Report: PUNCH LIST
Function: Test, Adjust, & Balance
Date: 02/04/2026
Completed By: National TAB

PROJECT
02-02-26 CULVERS - CHARLOTTE, NC

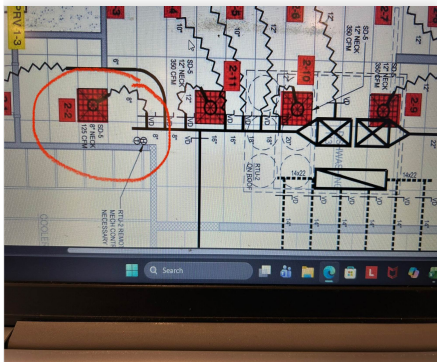
- Diffuser not installed.
- EF-1 Mop room fan
- RTU-2 ductwork undersized
- RTU-2 return ductwork damaged

Issue Name : RTU-2 ductwork undersized

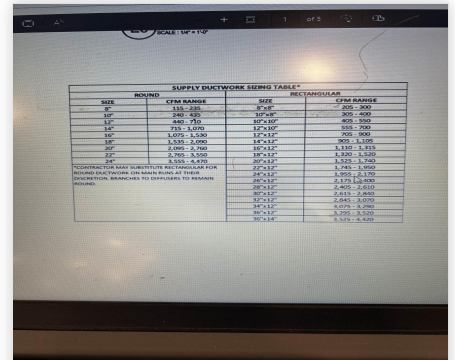
Description : RTU 2 is currently at 88% of design total flow. The ductwork from the unit was installed horizontally, this restricts the unit. On the MSET rooftop drawings refers to a note (M101) about proper ductwork size. Currently the supply ductwork 25x14 and also insulated inside. Supply pressure is at 1.50", the unit was at max amps 26.9a @61.5hz.

- **02/04/2026 National TAB - Jearod Ferrette**
 - The unit was slowed down by 2hz, to bring down the amps. Per the mechanical there is an email chain from Captive Air. The engineers wanted the unit to be ducted horizontally. This unit will be proportionally balance.
